Access Compliance Report

Public Rights-of-Way

Intersection ID: 23437	Main Street: TRYON_ST	Cross Street: MOSS_RD	Location: NW
ADA ID: 8C2BDC5CB1B6	Ramp Type: MedianPerp	Initial Pass/Fail: Fail	Overall Compliance: No
Severity Score: 8.75			
Codes/Mitigation Info/Possible Solution		Field Measurements/Component Compliance

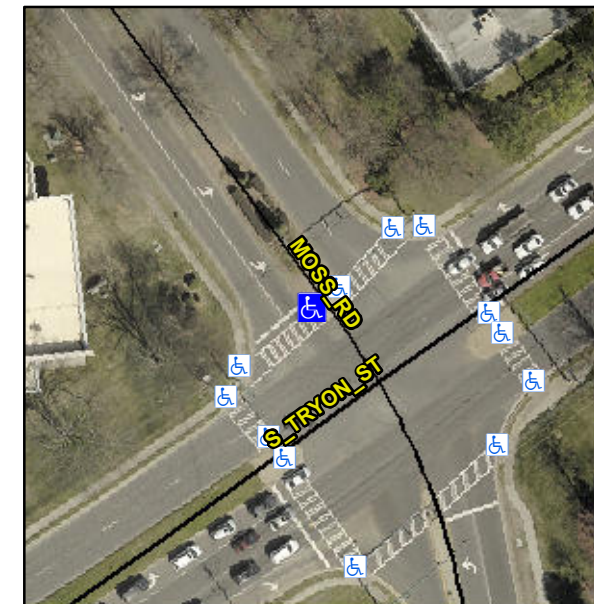
Not Found, R304.5.1

Compliance	Description	Data	Compliance	Description	Data
N/A	Ramp Length (in)	46.0	Yes	Ramp Slope (%)	6.6
No	Ramp Width (in)	41.5	Yes	Ramp XSlope (%)	0.8
N/A	Flare Type LT	N/A	N/A	Flare Type RT	N/A
N/A	Flare Slope LT (%)	N/A	N/A	Flare Slope RT (%)	N/A
N/A	Flare Traversable LT?	N/A	N/A	Flare Traversable RT?	N/A
N/A	Landing Length (in)	N/A	N/A	DWS Provided?	N/A
N/A	Landing Width (in)	N/A	N/A	DWS Contrast?	N/A
N/A	Landing Slope (%)	N/A	N/A	DWS Length (in)	N/A
N/A	Landing X Slope (%)	N/A	N/A	DWS Full Width?	N/A
N/A	Landing Curb? (Y/N)	N/A	N/A	DWS Offset (in)	N/A
N/A	Shared Landing?	N/A			
N/A	Gutter Ponding?	N/A	N/A	Gutter Slope (%)	N/A
N/A	Gutter Lip Ht (in)	N/A	N/A	Gutter X Slope (%)	N/A
N/A	Painted X Walk1?	Yes	N/A	Painted X Walk2?	N/A
	X Walk 1 Direction	To SW		X Walk 2 Direction	N/A
N/A	X Walk 1 Width (in)	111.0	N/A	X Walk 2 Width (in)	N/A
	X Walk 1 Slope (%)	0.7		X Walk 2 Slope (%)	N/A
	X Walk 1 X Slope (%)	1.9		X Walk 2 X Slope (%)	N/A

Remove & Replace Entire Ramp.
